ADDENDUM 4

REPORT ON CONTAINMENT BUILDING RING GIRDER  
CONSTRUCTION AND REPAIR

THREE MILE ISLAND NUCLEAR STATION

UNIT NO. 1

FIGURE 1 Part Section through ring beam showing sequence of repair pours for double dome tendon area

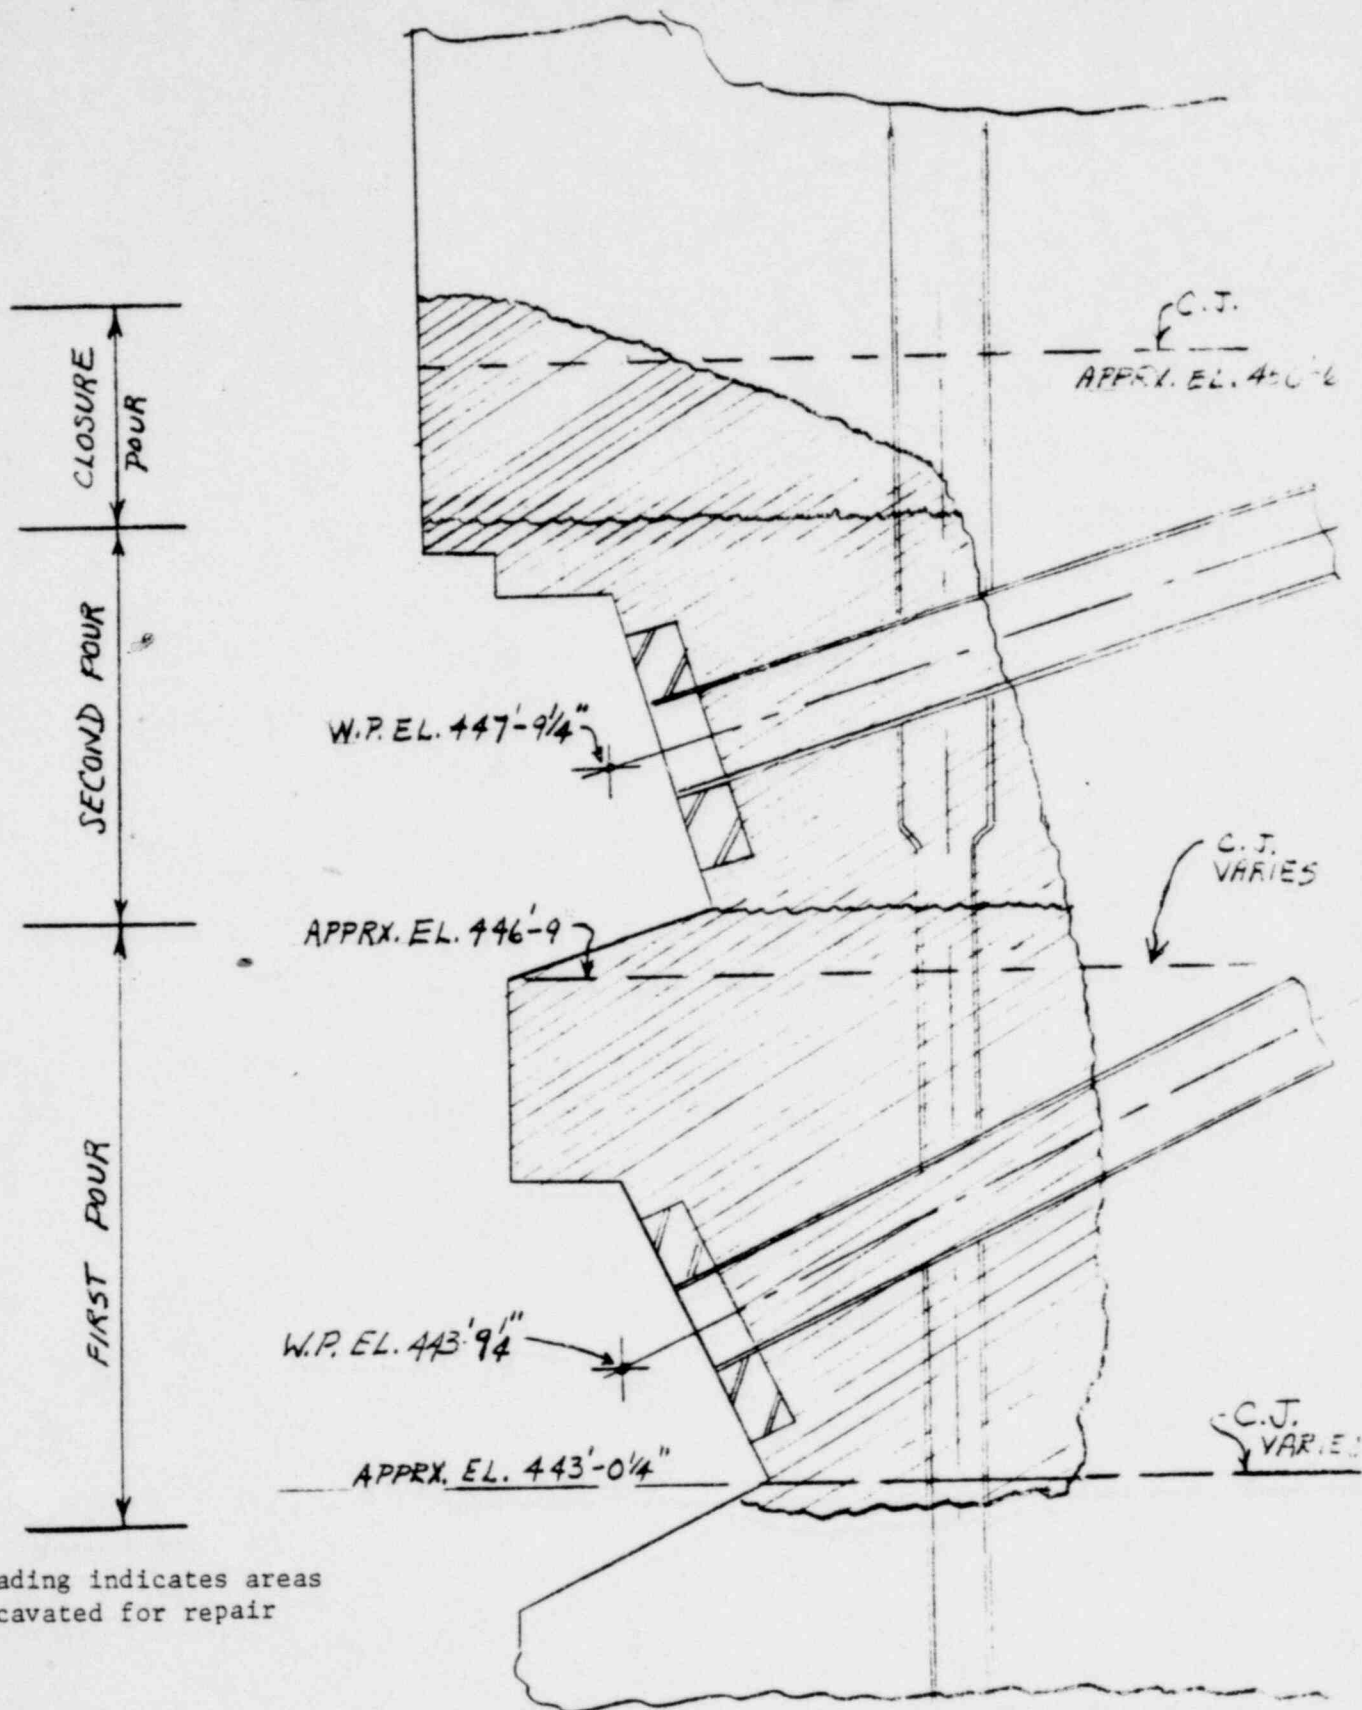
The horizontal ring girder construction joints at elevations 443 ft-0 in. and 446 ft-9 in. have been investigated for transfer of shear under load combinations including normal operation, initial prestress, accident, pressure test, seismic, wind, and aircraft impact. As originally constructed, the joints at these elevations extended horizontally across the entire ring girder section. Visual examination and core-borings as documented in Addendum 2 indicated that part of the joint extending in from the outside face of the ring beam was questionable for load transfer. The questionable areas of the joint have been completely excavated as shown in Figures 1, 2, and 3.

Visual and core-bore examinations confirm that the remainder of these horizontal joints left as originally placed is sound. The construction joints required for the replacement of concrete in the excavated areas (see Figures 1, 2, and 3), will be carefully prepared by green-cutting and other suitable methods to ensure that a sound construction exists prior to concrete placement. The repaired ring beam will perform its structural function as part of the reactor containment building as intended in the original design.

FIGURE 4 Coefficients of friction  $\mu$  at various azimuths required to transfer shear at elevation 443'-0" due to normal operation plus Aircraft Impingement.

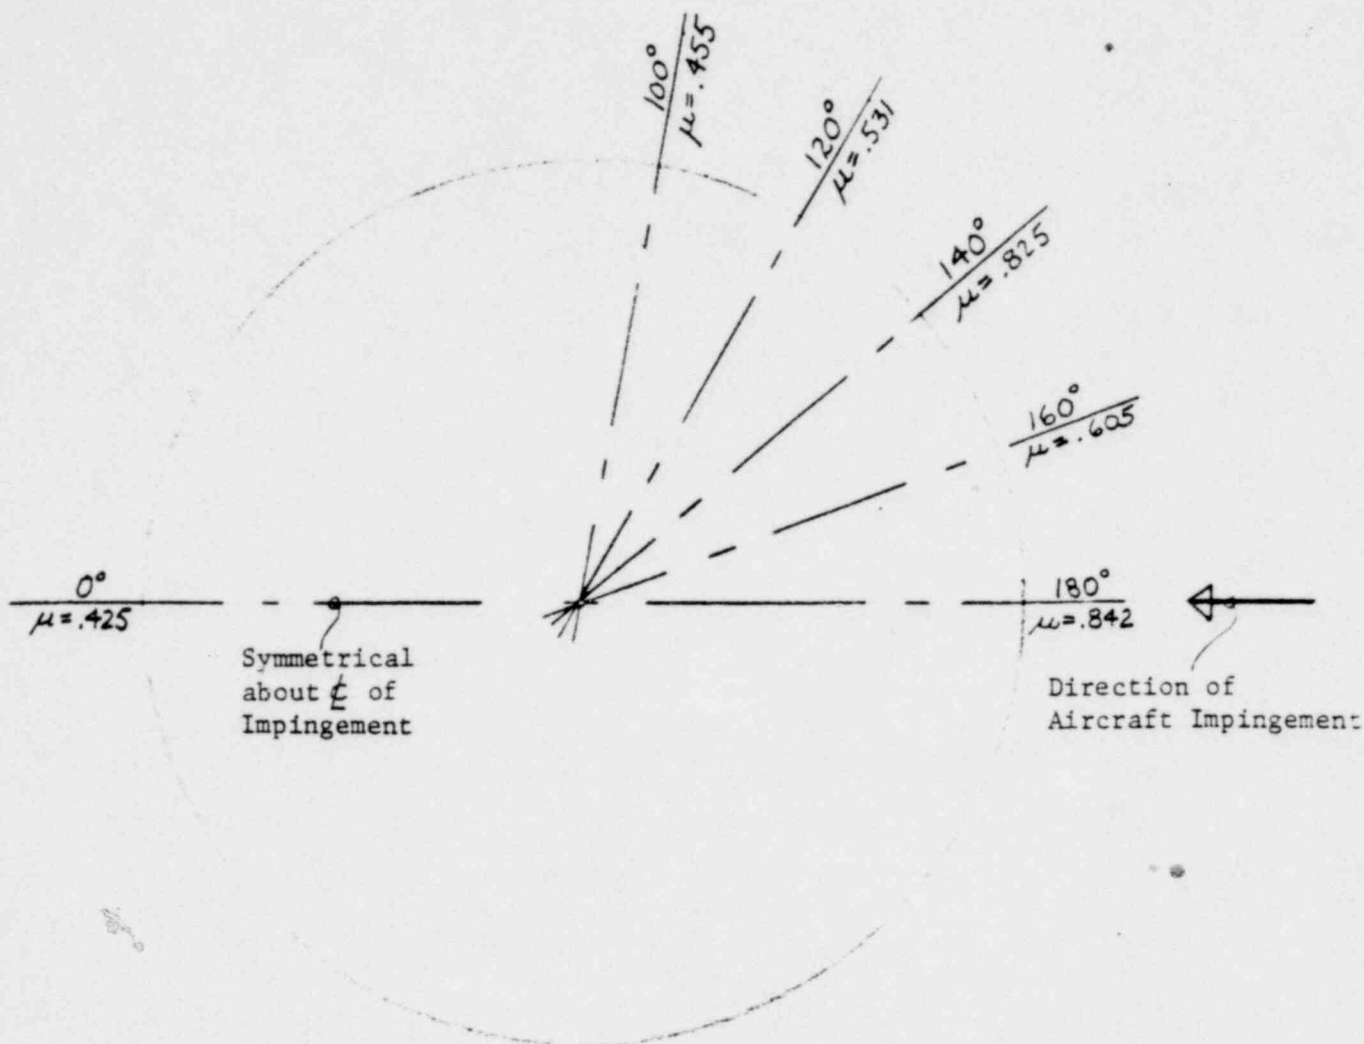
Addendum 3 should be clarified to reflect that the effect of Aircraft Impact Loading on the entire ring beam is generally small for the majority of the ring beam. Figures 4 and 5 indicate the required coefficients of friction to transfer shear at elevations 443 ft-0 in. and 446 ft-9 in. due to Normal Operation plus Aircraft Impact. The coefficients are conservatively derived using the greater of the in-plane shear or radial shear along with the normal force in the conventional friction equation  $F=\mu N$ .

From Figures 4 and 5 the required coefficients of friction are seen to be less than or equal to the allowable value of one. For the majority of the ring beam, the minimum factor of safety is still two under this load. However, for part of the ring beam where the required coefficient of friction is greater than 0.7 (the ultimate coefficient of friction 1.4 divided by a factor of safety 2 is equal to 0.7), the minimum factor of safety will be less than 2.

FIGURE 5 Coefficients of friction  $\mu$ , at various azimuths required to transfer shear at elevation 446'-9" due to normal operation plus Aircraft Impingement.

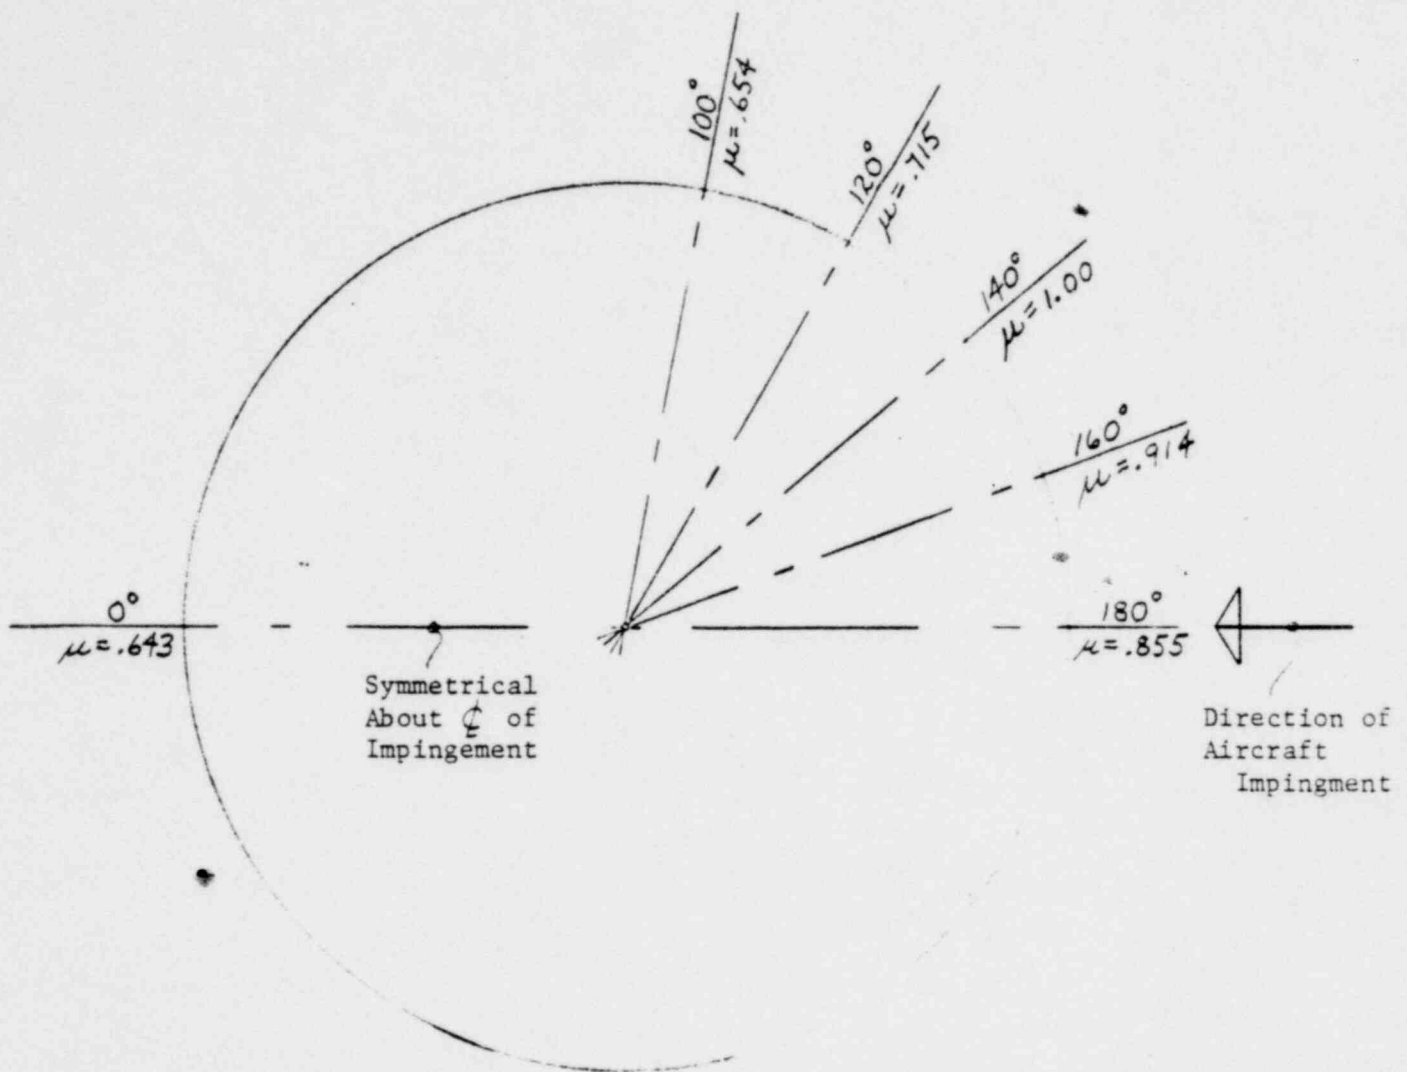
The lowest factor of safety will be 1.4 in the area around 140° shown on Figure 5. At that location the required coefficient of friction is  $\mu=1.00$ . A factor of safety of 1.4 is derived by dividing the assumed ultimate coefficient of friction 1.4 by the required value of  $\mu=1.00$ . Since it has been conservatively assumed that the shear is carried across the joint only by friction under a normal compressive stress, a minimum factor of safety of 1.4 for a limited portion of the ring beam is considered adequate under the Aircraft Impact Loading.
